AGENDA
City of Dallas Planning Commission
TUESDAY, January 10, 2017 - 7:00 p.m.
City Hall Council Chambers
187 SE Court Street

**STAFF REPORT
DATE: JANUARY 3, 2017**

| REQUEST | SITE DESIGN REVIEW APPROVAL FOR A NEW SENIOR CENTER AND RELATED SITE UTILITY AND LANDSCAPE IMPROVEMENTS. |

HEARING DATE: JANUARY 10, 2017
APPLICATION TYPE: SITE DESIGN REVIEW
OWNER: CITY OF DALLAS
APPLICANT: REX PRICE, ARCHITECT
APPLICATION: TO CONSTRUCT A NEW SENIOR CENTER.
LOCATION: **187 SW Court Street & 950 SW Church Street**

1 SOUTH ELEVATION
 SCALE: 1/4"=1'-0"

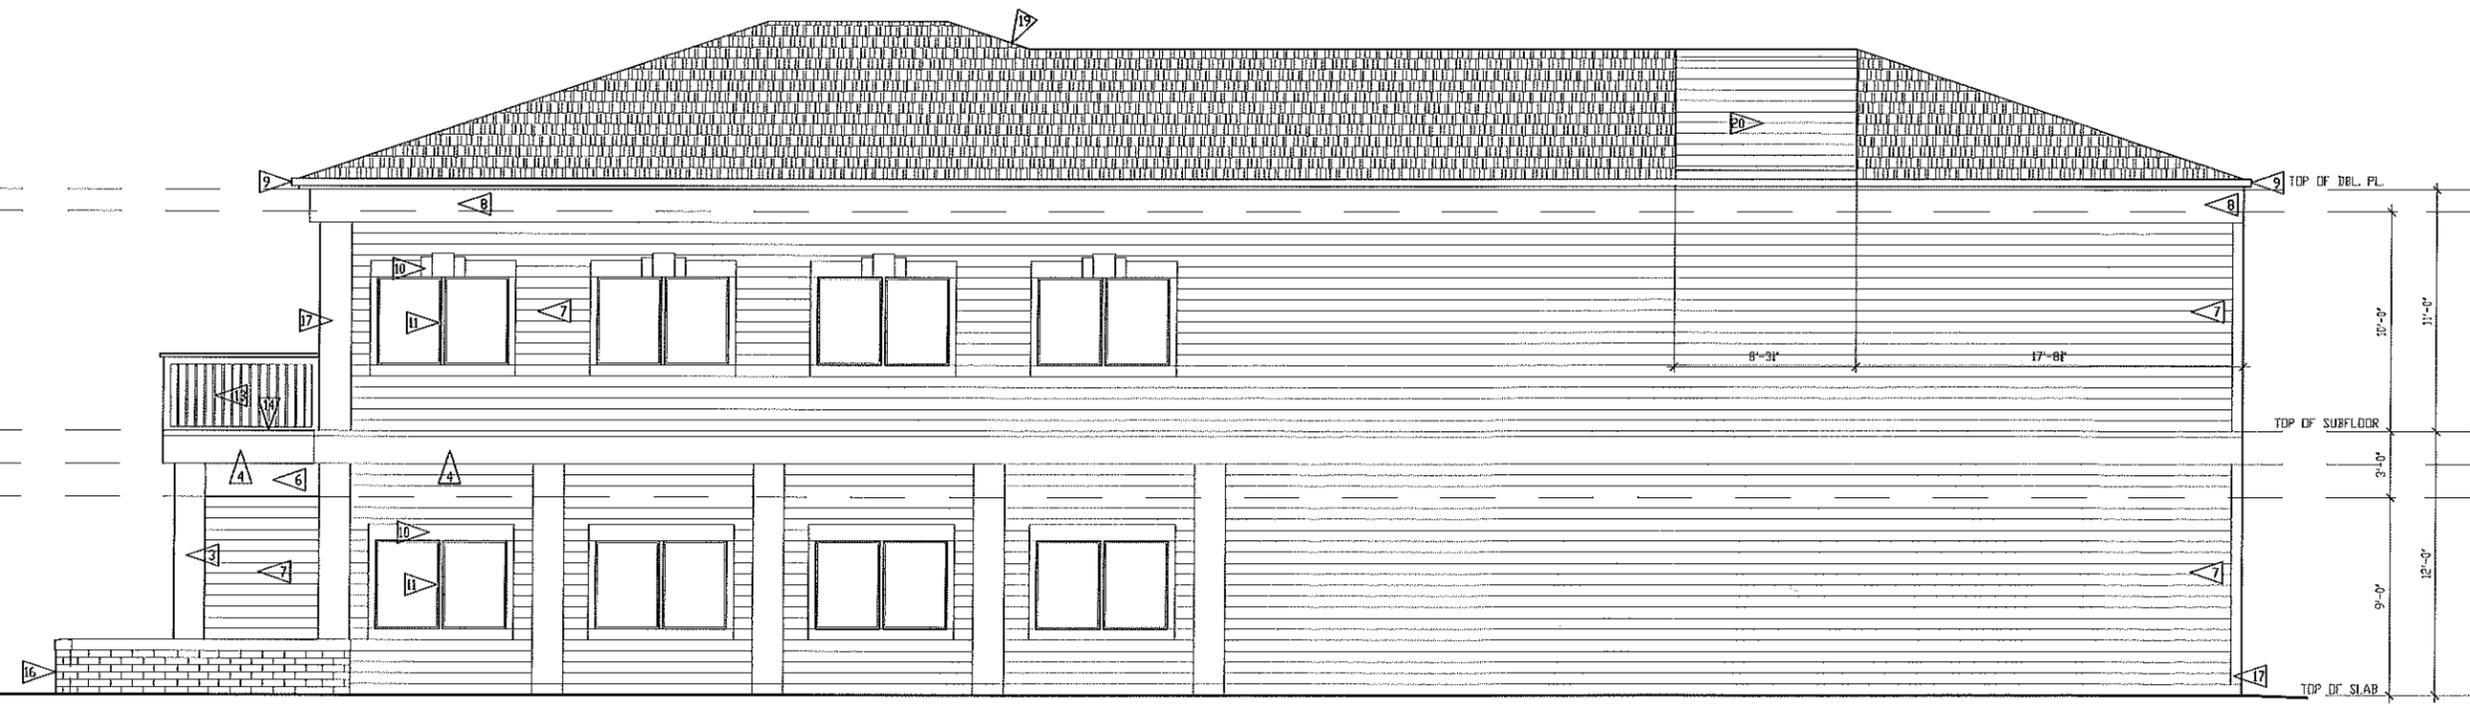
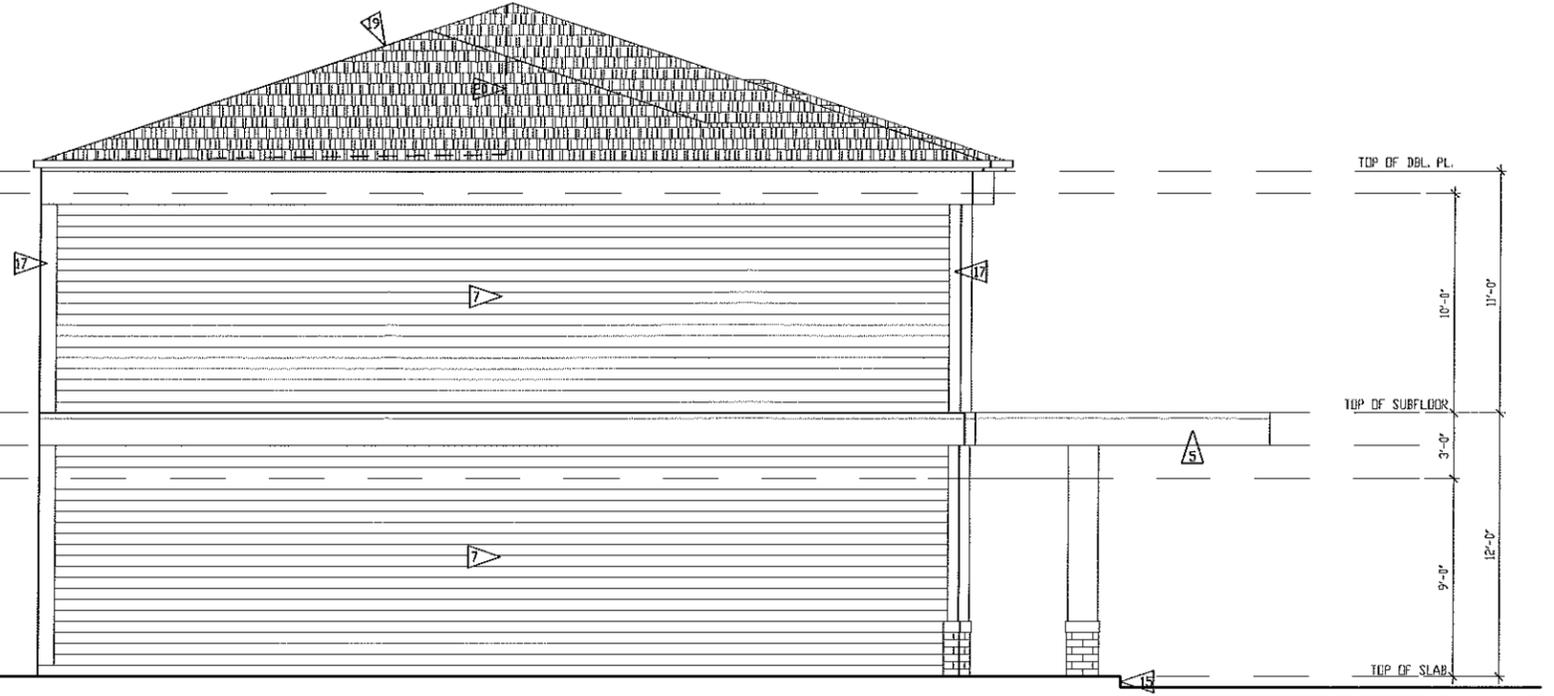
L. Materials and Color – Exterior building materials shall predominately consist of brick, wood or fiber cement, stucco, stone and/or similar masonry. Pitched roof materials shall be wood or asphalt shingles, or standing rib seam sheet metal-matte finish. All windows and doors must have wood or vinyl trim that is at least four (4) inches deep, or masonry trim and sills with a similar depth. The predominate exterior cladding materials for the proposed building is horizontal lapped siding. Changes in building materials include the use of brick to define the building base and stucco columns along the facades visible from the street and parking area.

All Mechanical equipment is located at a roof well 2 stories above the ground level and does not impact the Eastern adjoining neighbor. See A3.1 We do not plan to install any small scale renewable energy equipment on the building, now or in the future. We do not have any mechanical equipment mounted on the ground or exterior walls of the building.

LANDSCAPE SITE PLAN

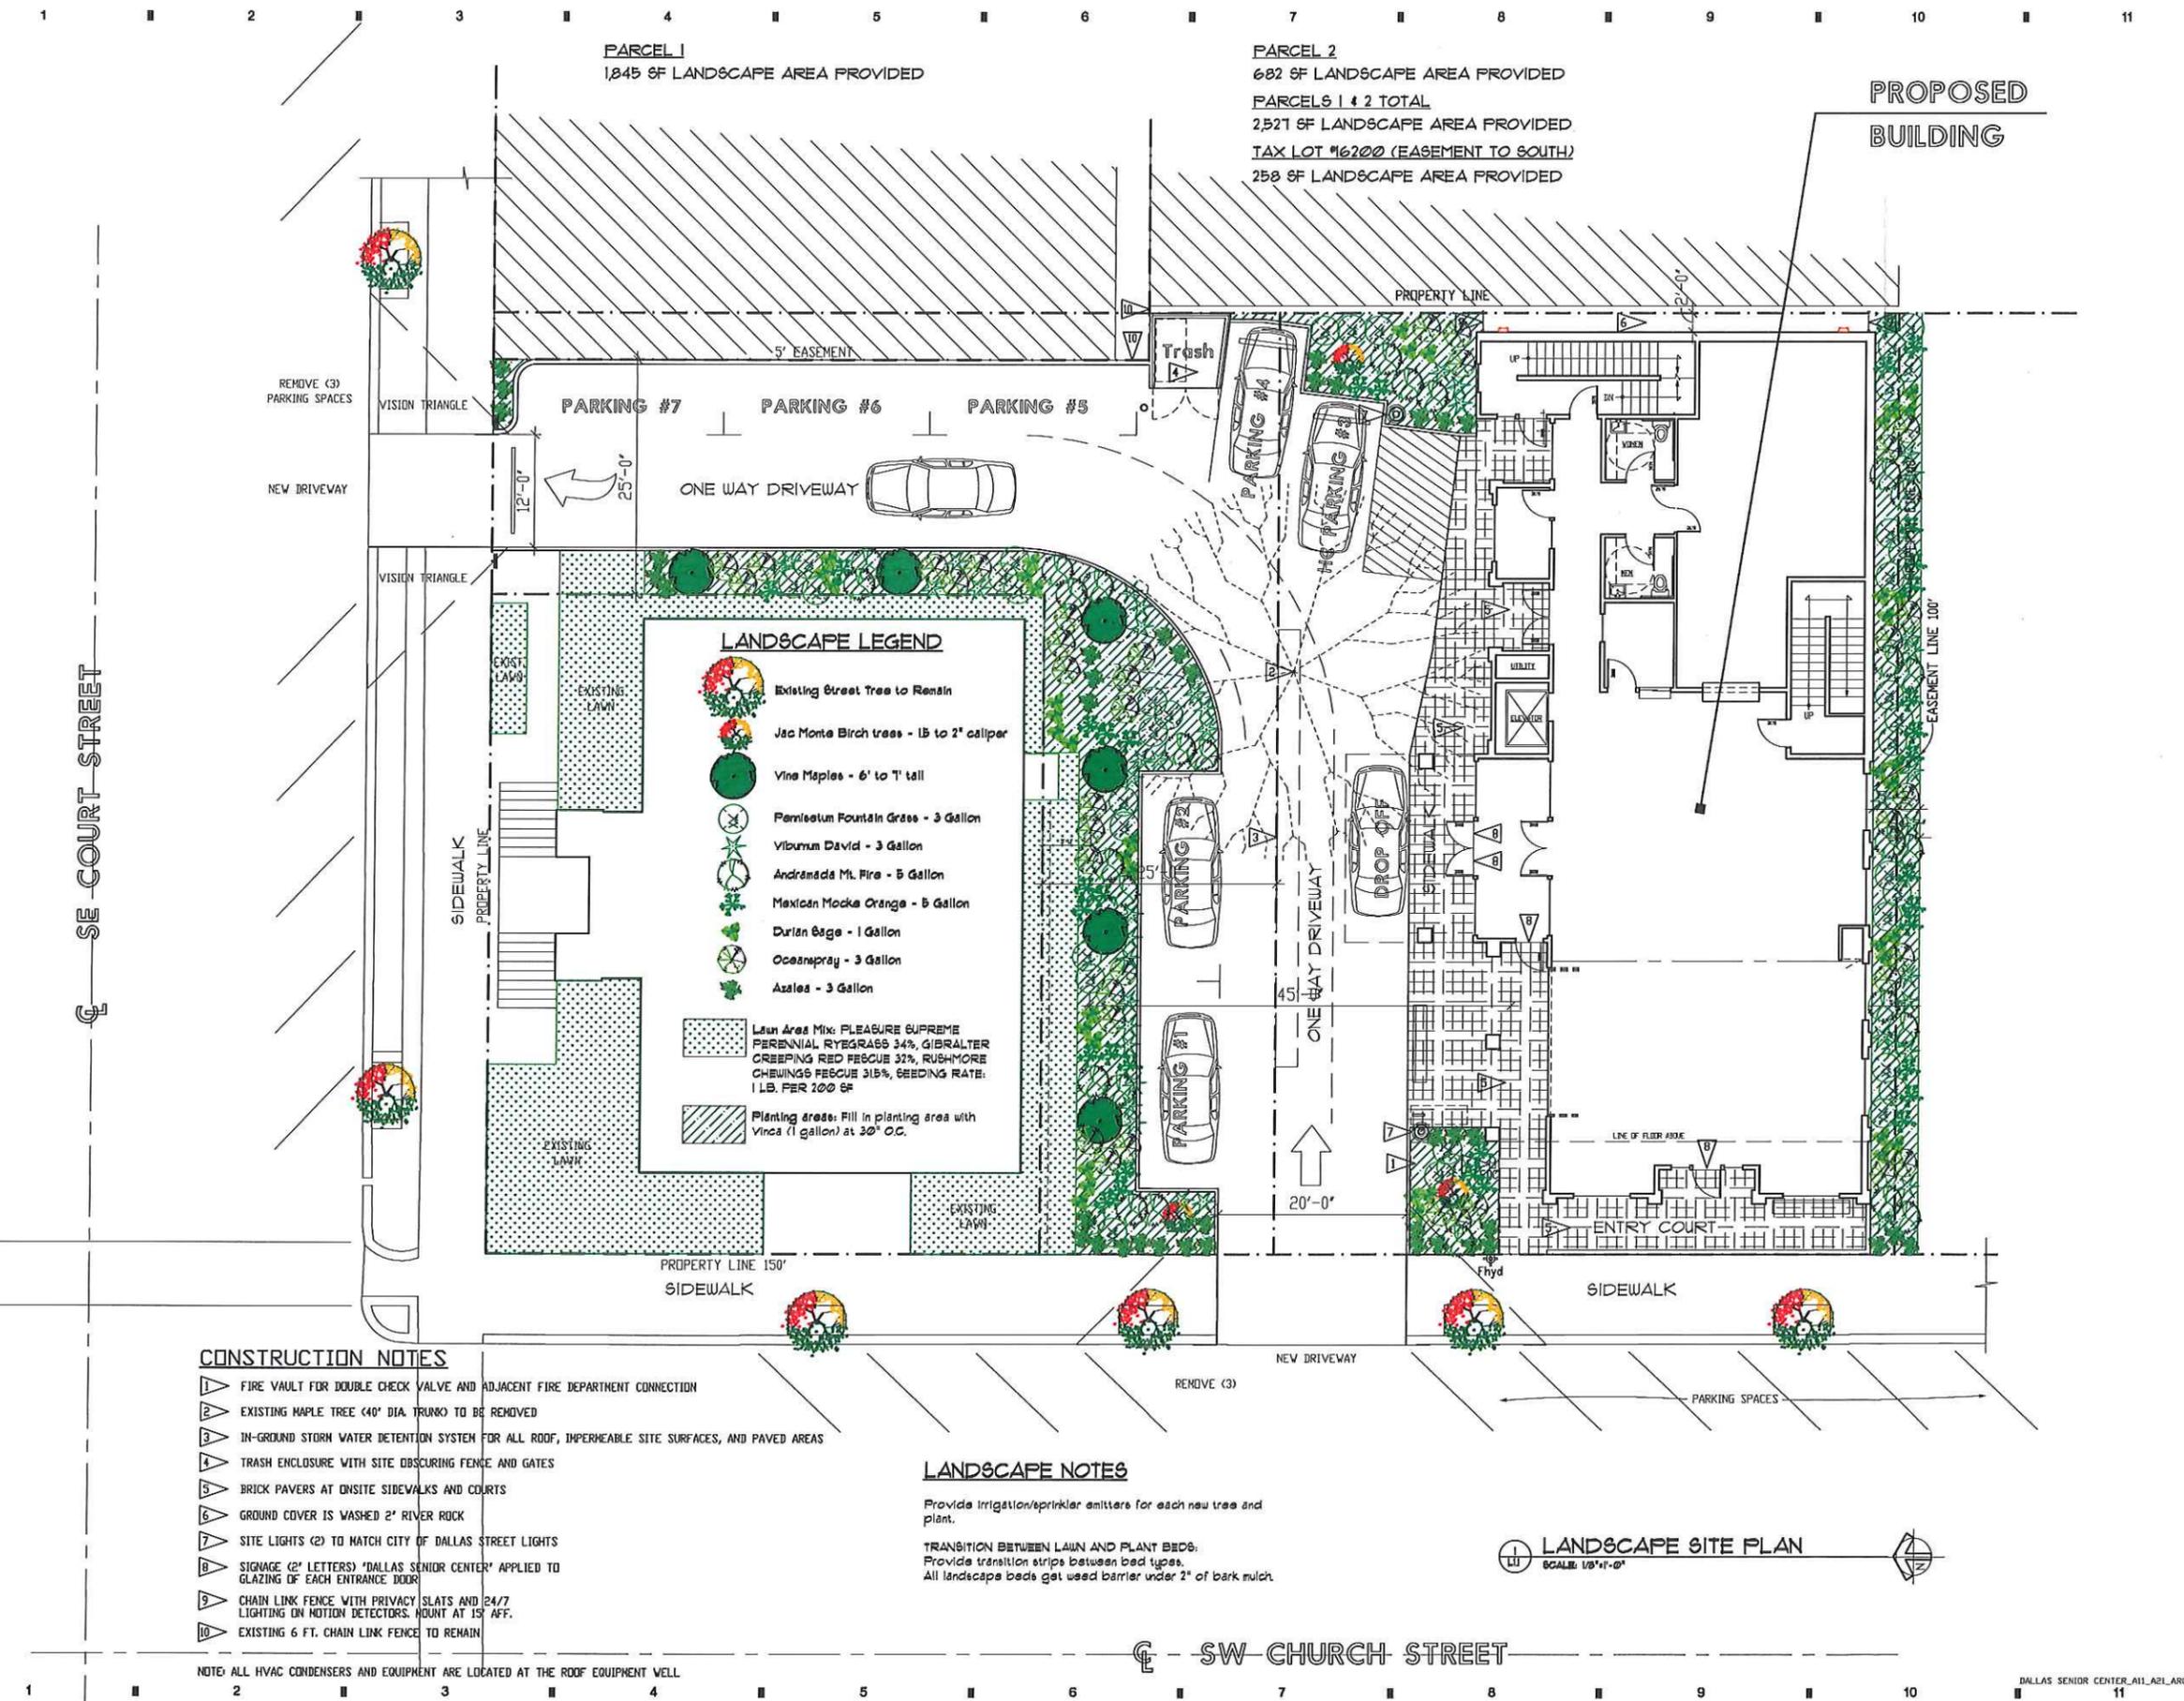
A landscape plan was submitted with the Site Design Review application. The plan shows a total landscaped area of 2,527 sf for the entire site, which exceeds the minimum five (5) percent landscape requirement of 734 sf for the site. The proposed landscaping shown on the Applicant’s plan indicates a combination of deciduous and evergreen trees, shrubs, hedges and ground covers. All landscape materials will meet or exceed the minimum caliper or height for trees and the shrubs will be five (5) gallon or larger in size. The design of the proposed landscape areas takes into account the landscape design standards found in Section 3.2.030.E and have been placed around the building in a manner to create visual interest and scale but allow for adequate natural light. Trees have been added along the building as well as throughout the parking lot areas. The type of trees and its locations were chosen to provide various focal points within the development and shade without conflicting with overhead utilities and clear vision requirements.

The notes for the landscape plan indicate the site will be served by irrigation/sprinkler emitters for each new tree and plant.
